**Port of Tyne Application DC 6742**

From: Dr C Vivian  
Date: 18 June 2003  
Room: Rm 102  
CEFAS, EM  
Burnham Laboratory  
Tel: 016 2178 7253 (direct line)  
Email: c.m.g.vivian@cefass.co.uk

Some further thoughts following the meeting with the Port of Tyne (PoT), Keith Wilson's letter to you dated 5 June 2003, my further examination of the application documents and discussions at Burnham with CEFAS colleagues:

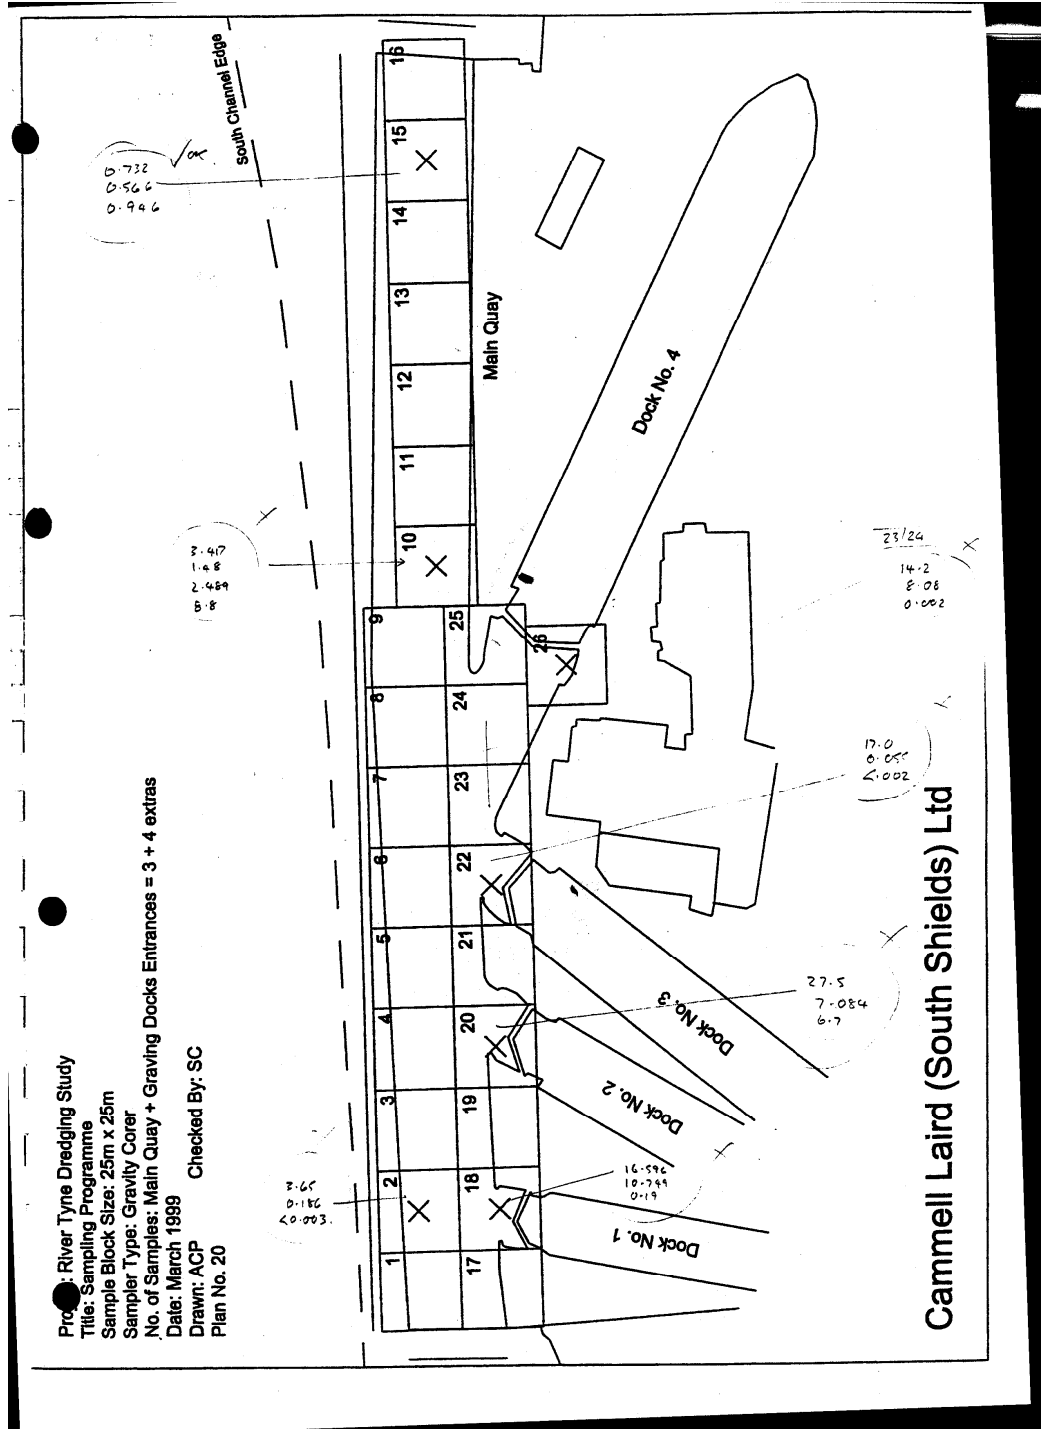
3. While Figure 1a calls the flow diagram a 'decision pathway', it has always been recognised in the Conventions that it should be used iteratively and not just in a step by step fashion.
